**Ironbark No. 1 Coal Mine – EA Amendment
Application**

Response to DES Additional Information Request

**for Fitzroy Australia Resources Pty
Ltd**

9 June 2023

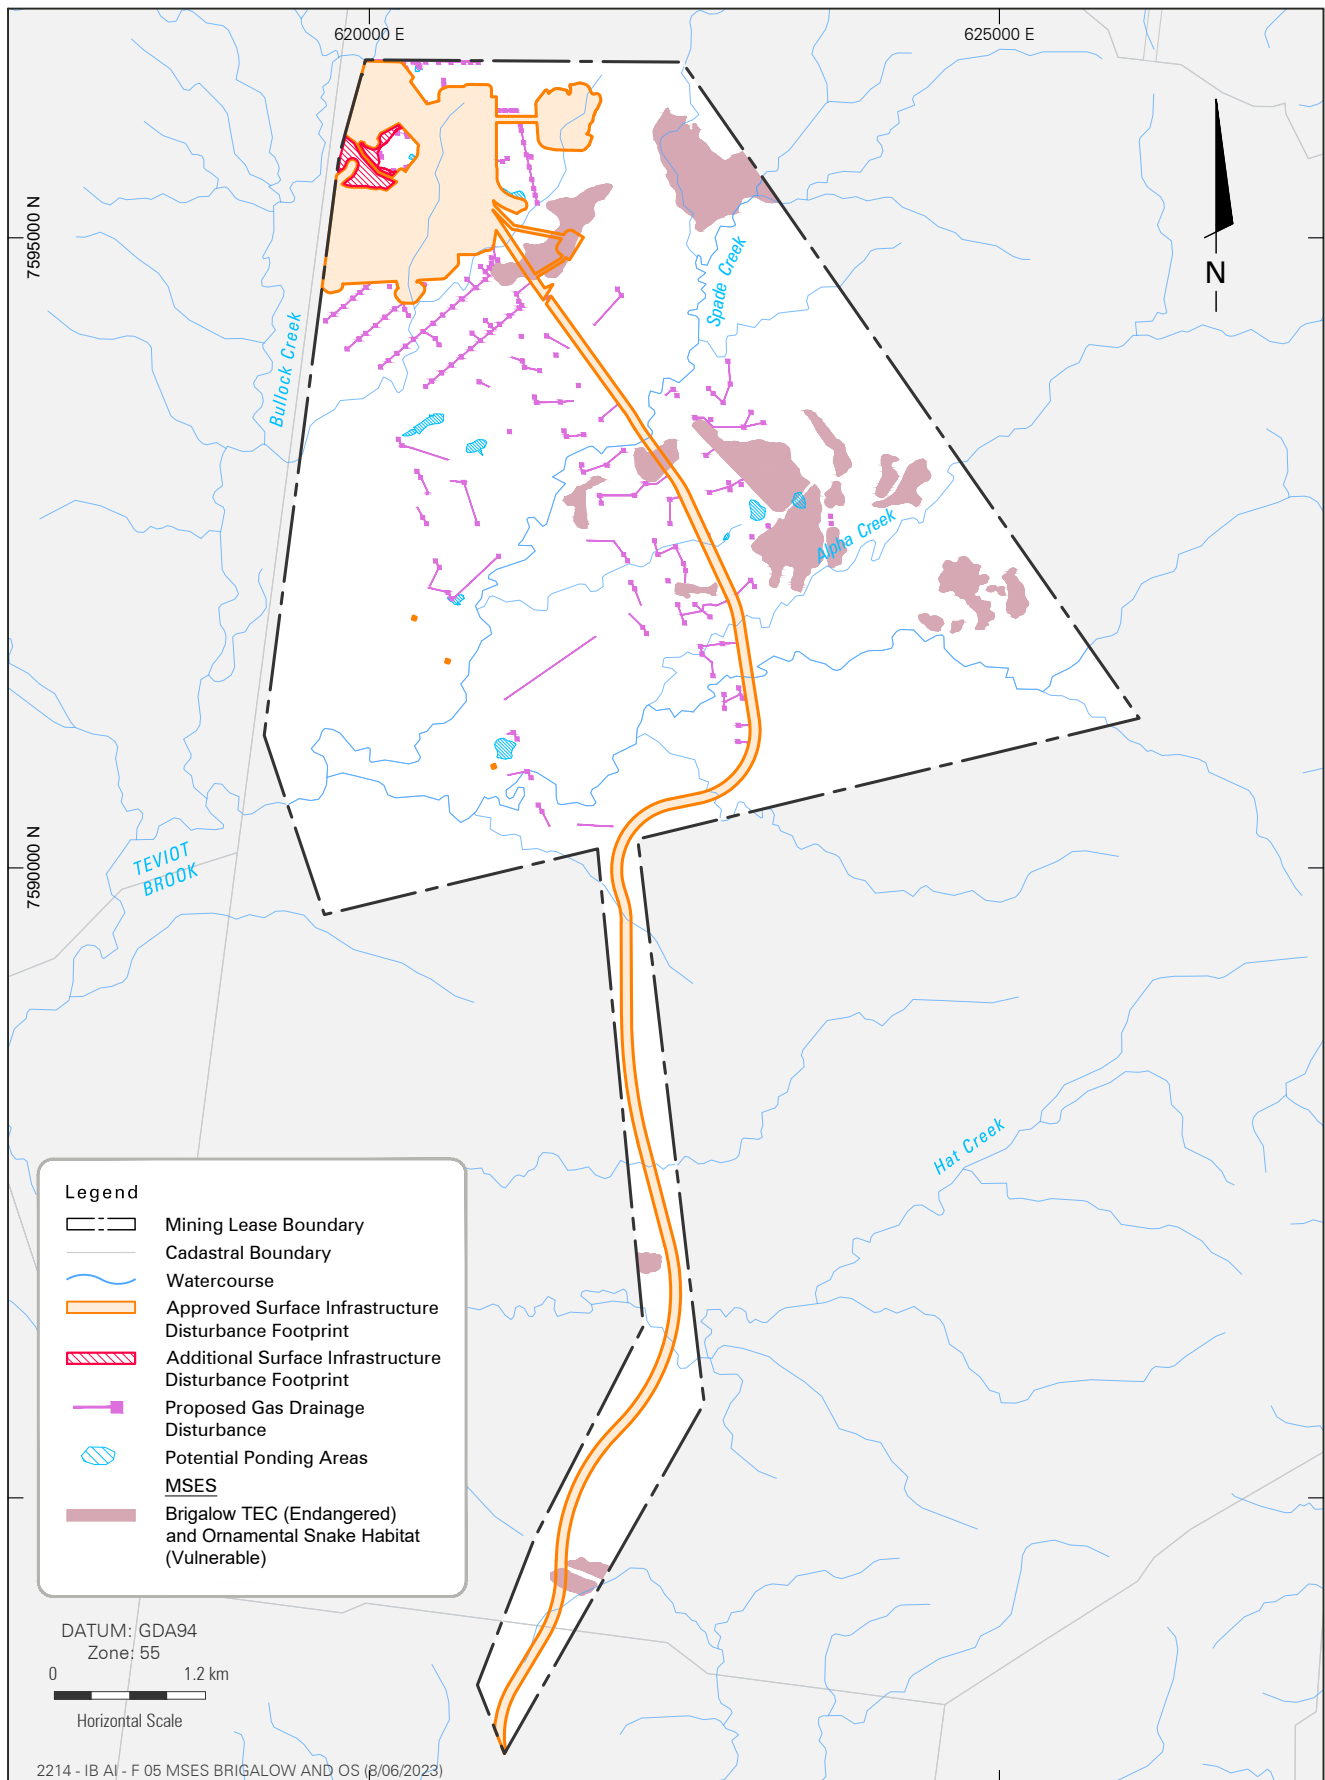
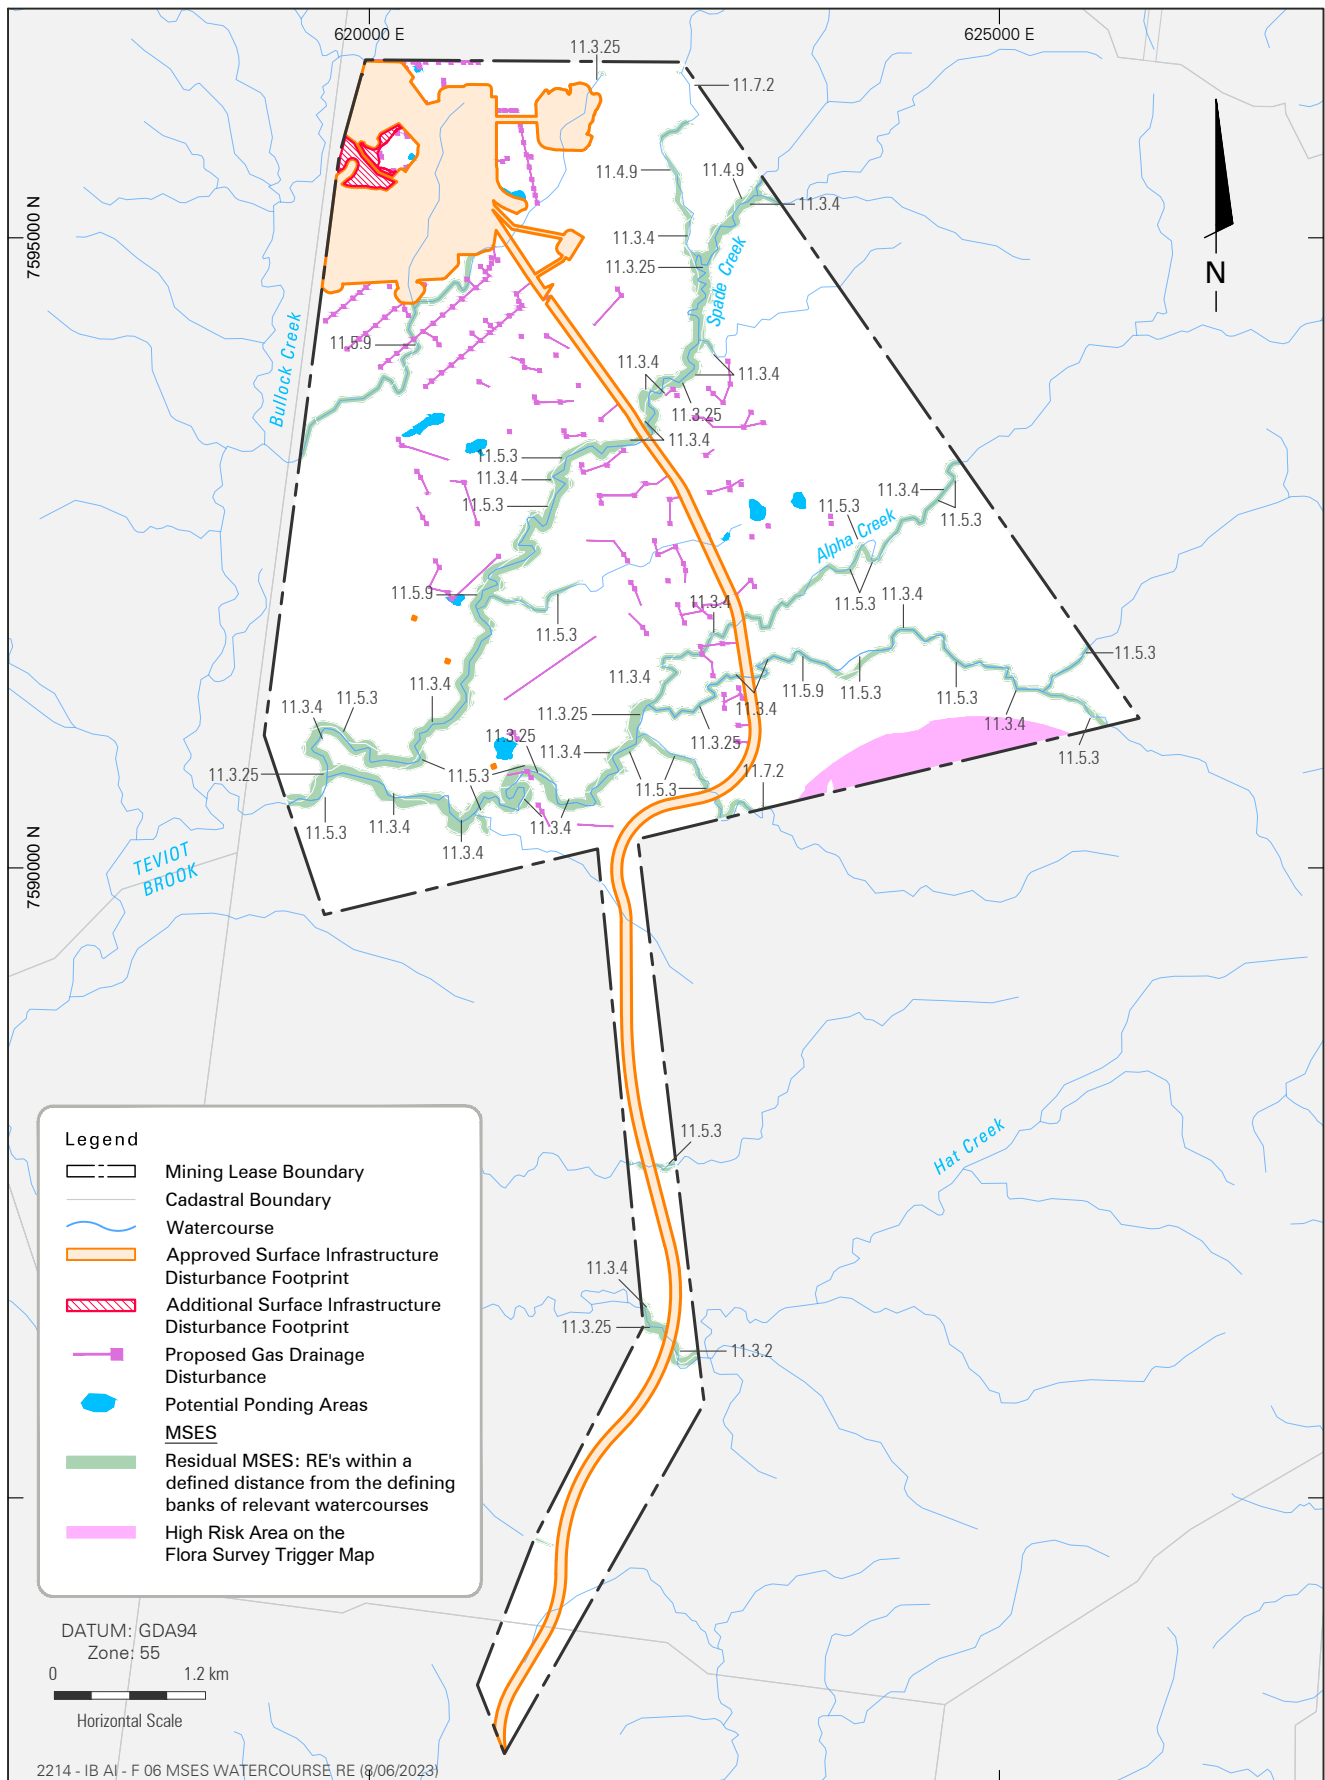
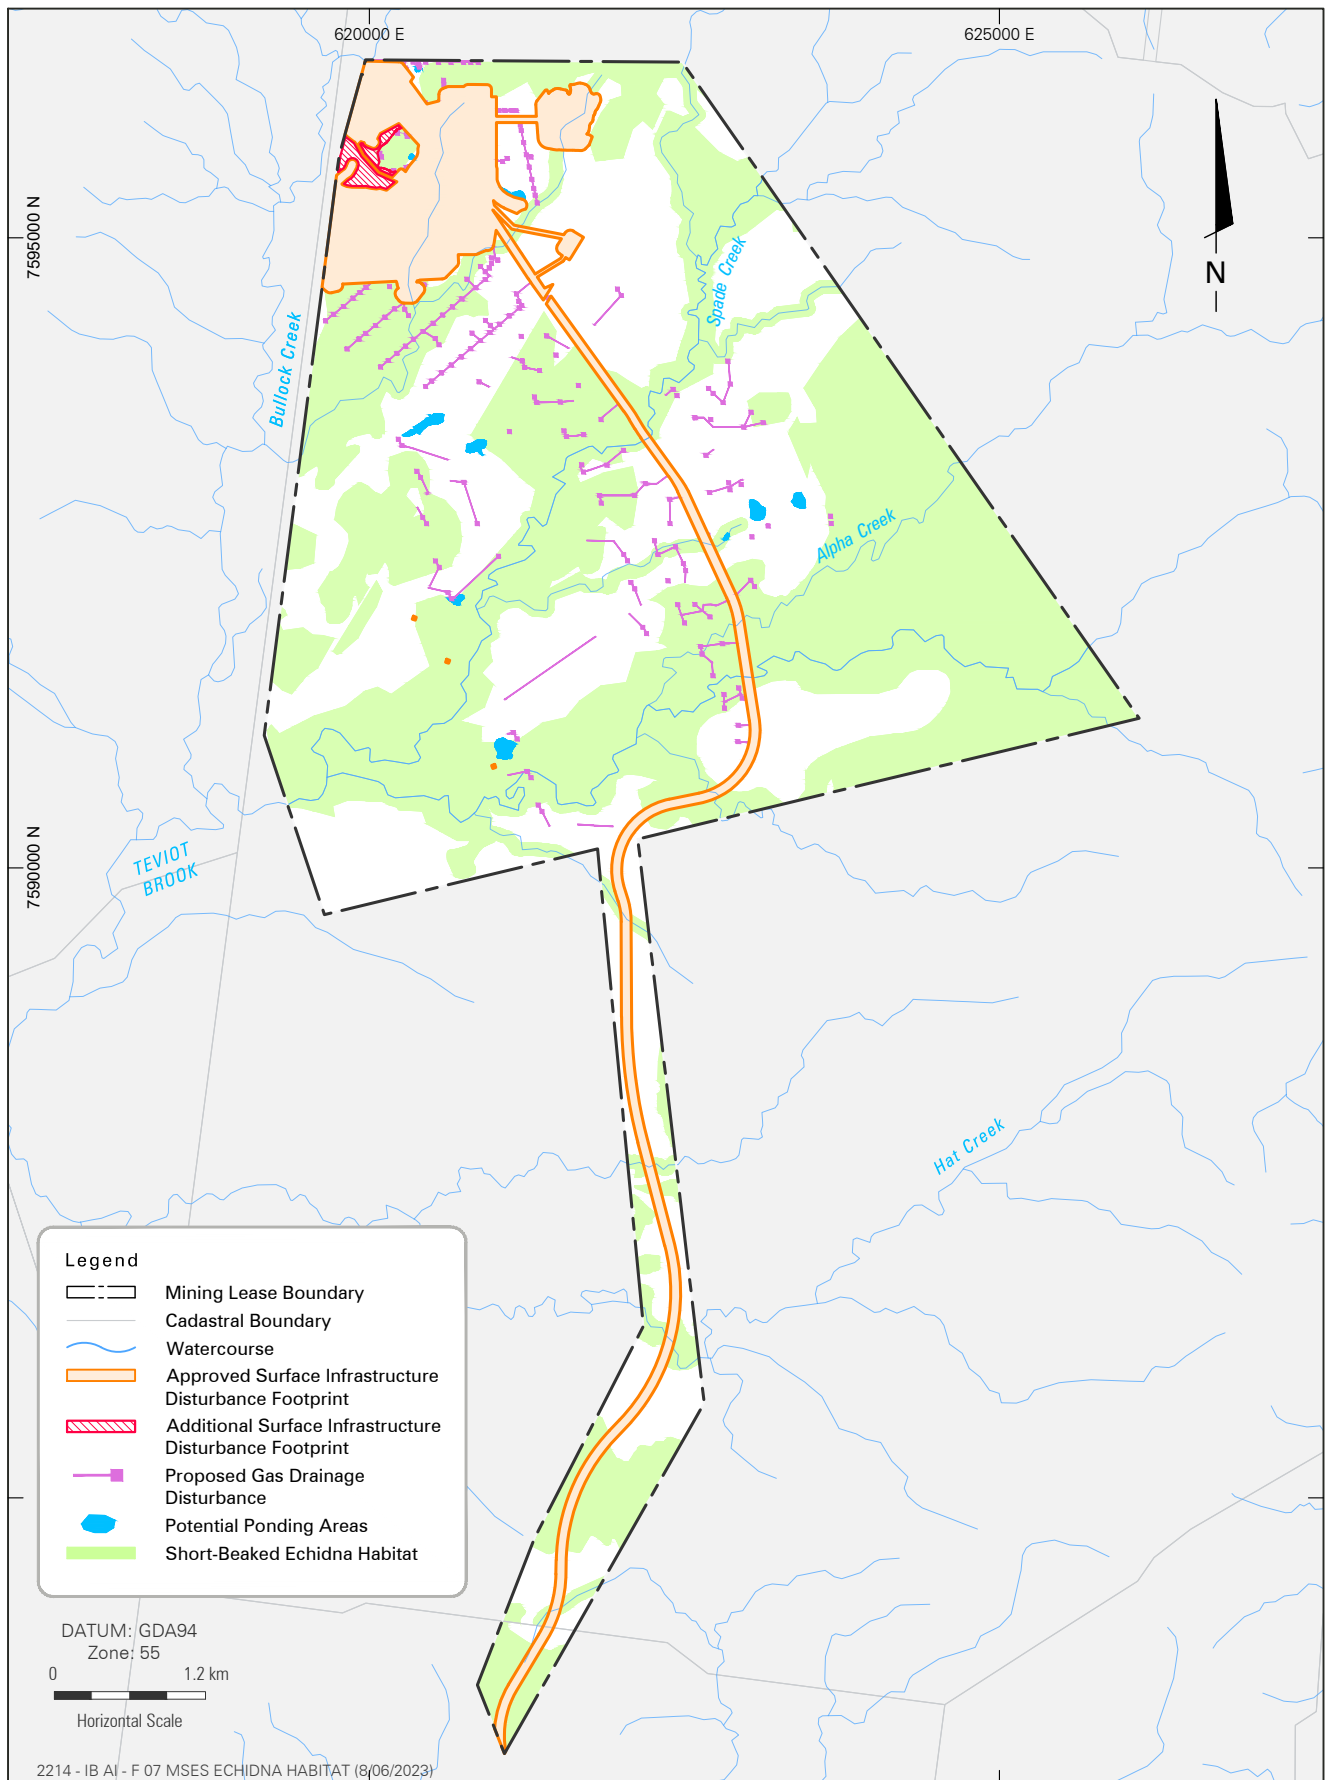
DES Issue: *An ecology report was provided with the supporting documentation; however, it only addressed the ecology impacts associated with the additional surface disturbance areas. No ecological assessment was provided for the surface impacts relating to subsidence of the underground mining area, or for impacts from rehabilitation of subsided areas.*

DES Request: *Evaluate the impact of the revised project (both surface infrastructure and surface disturbance—including from rehabilitation activities—from the underground mine) on MNES and MSES and show in a table and figures.*

The combined impacts from the approved disturbance area (EA Appendix 1), the additional surface infrastructure disturbance footprint, subsidence ponding and the LOM gas drainage disturbance areas are shown in Table 2. Figures showing the extent of, and impacts to, each MSES within the mine site are shown in Figure 4 to Figure 7.

Figure 1 Predicted drawdown at end of mining in Layer 2

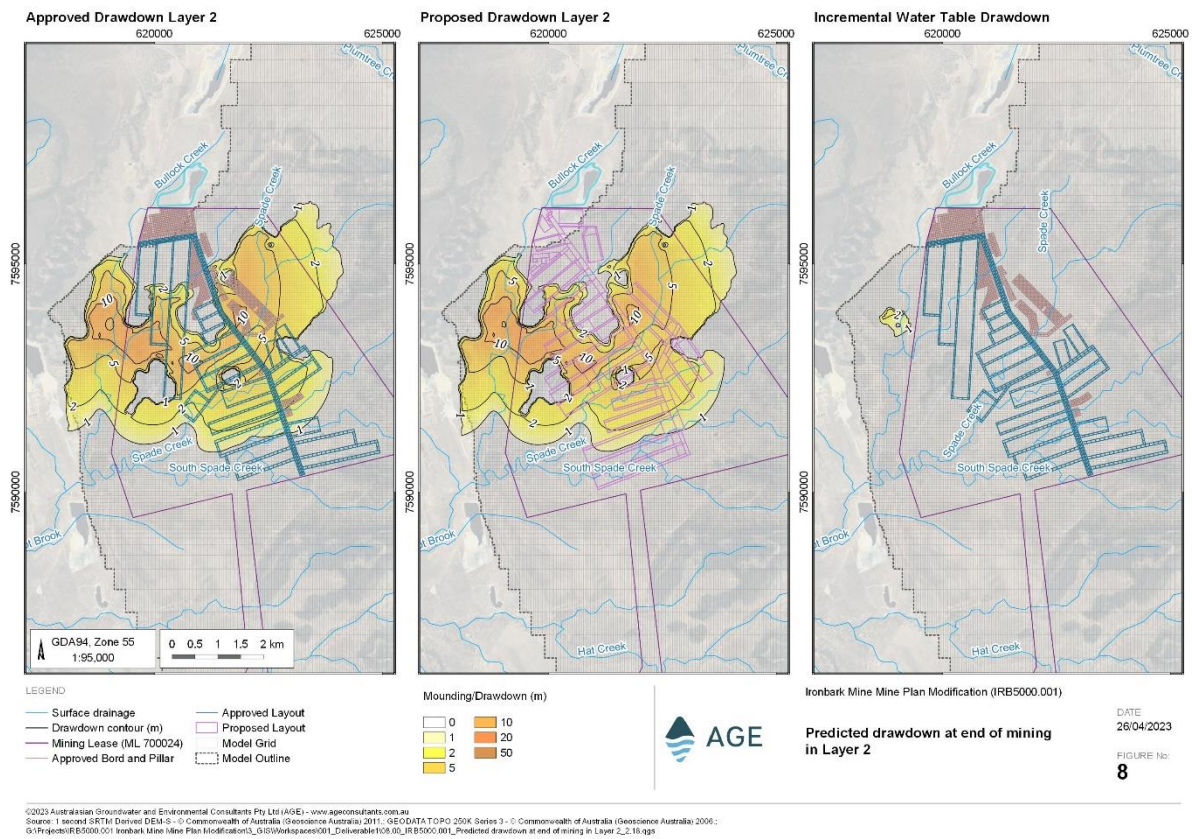
Item 2.2 of the informal IR requested drawdown contours for the Rewan Formation and the Regolith. These maps were provided for the 'Predicted drawdown'. Similar to Appendix C, Figure 7 of the supporting information with the application, DES requires three separate figures for Layer 2 (Rewan Formation), titled 'Approved drawdown', 'Proposed drawdown' and 'Incremental drawdown' (showing the difference between the two).

DES Request: Provide three figures for the drawdown contours for the Rewan Formation, similar to Appendix C, Figure 7 of the application supporting information.

Request: *“Provide figures with predicted drawdown contours, similar to Appendix C Figure 7, separately for the Rewan Formation and the Regolith (layer 1). Please also provide information in regard to the modelled thickness of the Regolith.*

Response: The predicted drawdown within model layer 2 (Rewan Formation) for the approved and proposed mine plans is provided in Figure 1 below. The difference in the drawdown is also shown on Figure 1 in the right side window. There are some areas where drawdown is not predicted because layer 2 is dry in the model, and the water table occurs within a deeper underlying model layer. The Rewan Formation is represented by model layers 2 to 21 in the model, and therefore the predicted drawdown will change through the model layers based on the hydraulic properties and proximity to mining. Layer 2 drawdown was provided because it represents the upper zone of the Rewan Formation closest to the land surface. Figure 1 indicates there is likely to be limited difference in impacts at the surface due to proposed changes to the mine plan.
